**PLANNED UNIT DEVELOPMENT  
& SUBDIVISION STAFF REPORT****Date: April 2, 2020****DEVELOPMENT NAME**

IHS Medical Park Subdivision, Phase Two

**LOCATION**1721 & 1725 Spring Hill Avenue  
(South side of Spring Hill Avenue, 140'± West of  
Gilbert Street).**CITY COUNCIL  
DISTRICT**

**AREA OF PROPERTY**1 Lot / 2.7± acres (Subdivision)  
2 Lots/ 6.7 ± acres (PUD)**CONTEMPLATED USE**Planned Unit Development Approval to allow shared  
access and parking between building sites, and Subdivision  
approval to create one (1) legal lot of record from four (4)  
metes-and-bounds parcels.**TIME SCHEDULE  
FOR DEVELOPMENT**

# SITE PLAN

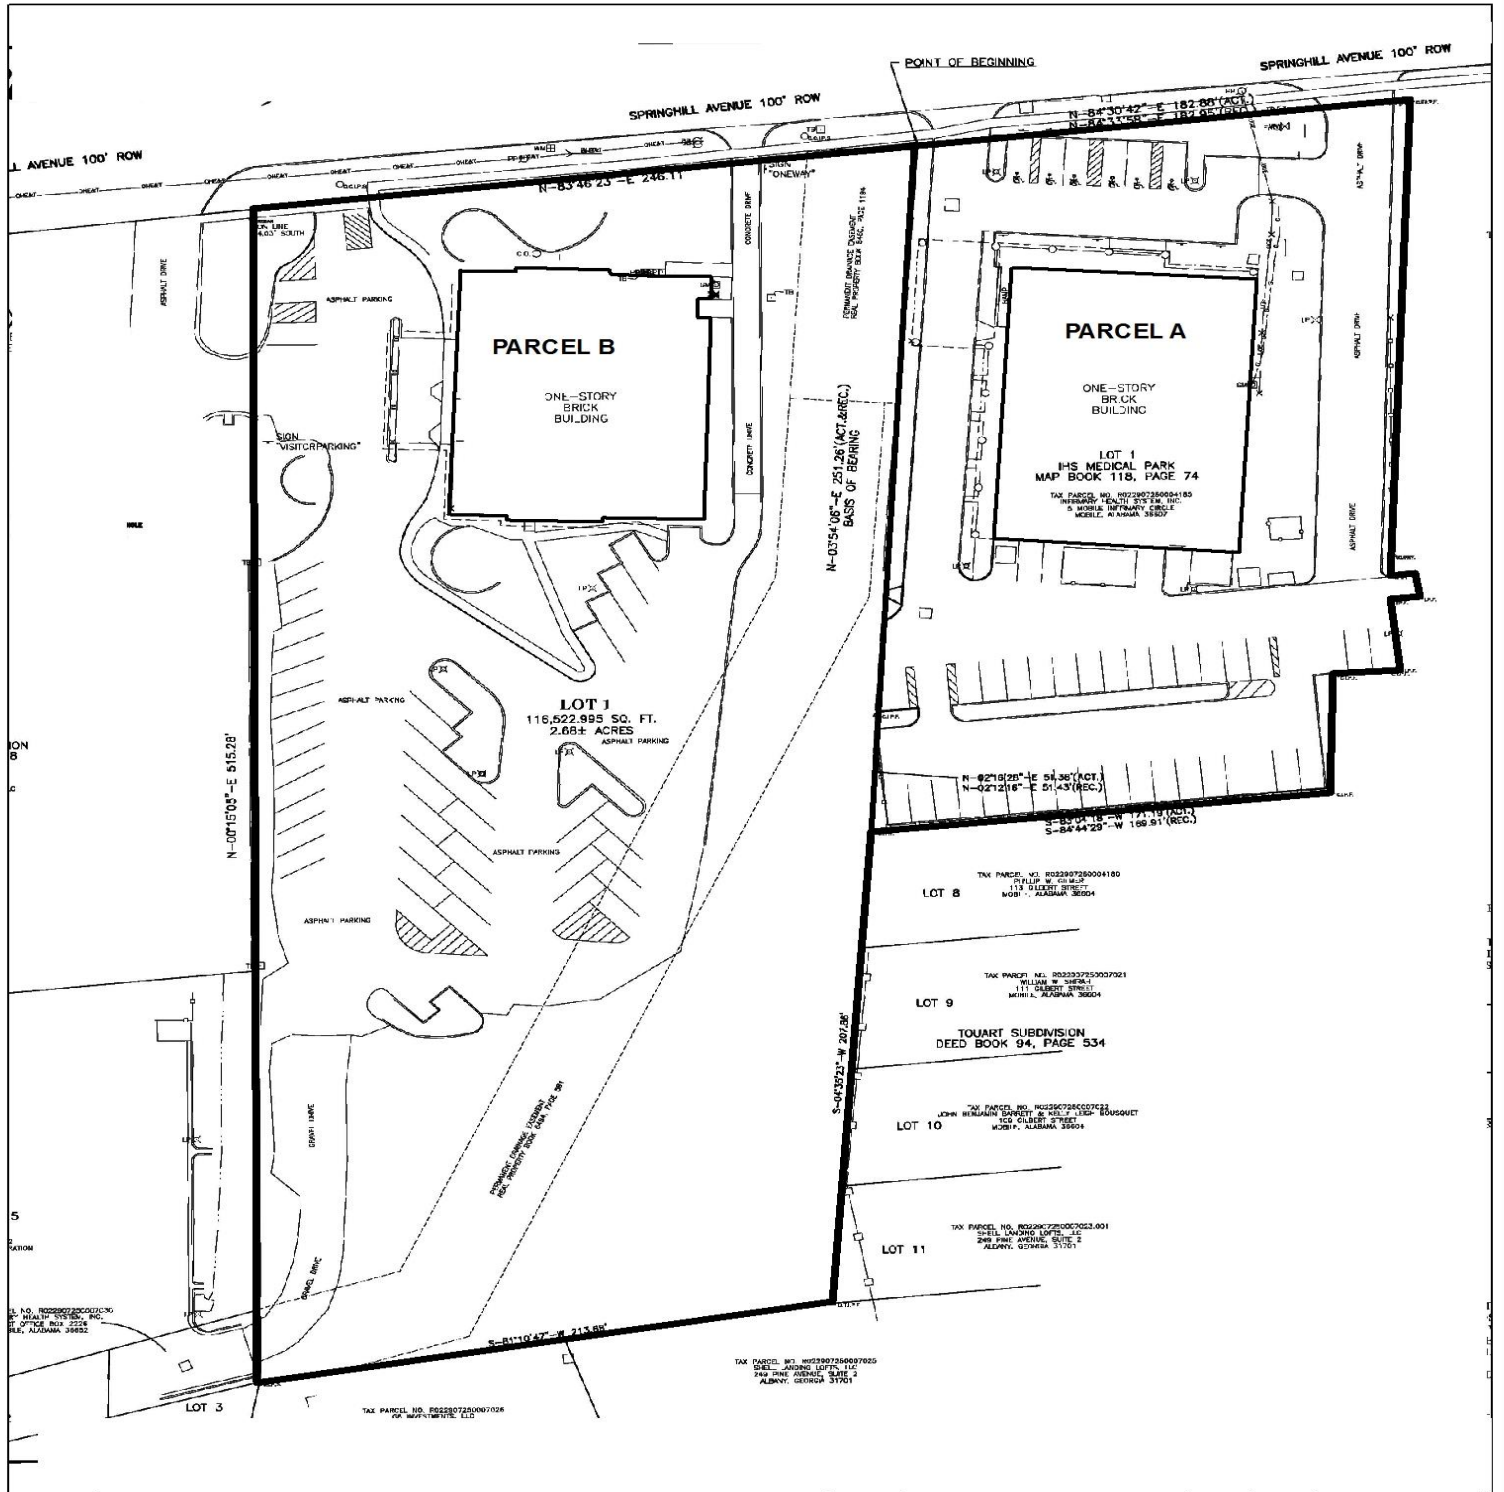
The applicant is not proposing to make any changes to the existing structures on the site, but is proposing to add some additional driveways and 52 parking spaces. The driveways will connect the two building sites, and create a total of 132 parking spaces. Because the number of parking spaces will be increased more than 25%, a photometric plan will be required at the time of permitting. Because the footprint of structures is not changing, no tree and landscaping compliance will be required at this time.

It should be noted that the site plan depicts existing shared access with building sites to the West of the subject site. A previous Administrative Planned Unit Development allowed this shared access, and as such, those adjacent properties should be included in the subject application. Because the applicant was advised by staff that the adjacent property owners must authorize an amendment to the previously approved PUD and that those properties must be depicted on the site plan and neither of these was done, the Planning Commission cannot consider the request without the consent of all property owners involved.

**Planned Unit Development:** The Planning Commission cannot consider the PUD application for approval as not all affected property owners have authorized the application, nor are all affected properties shown on the site plan.
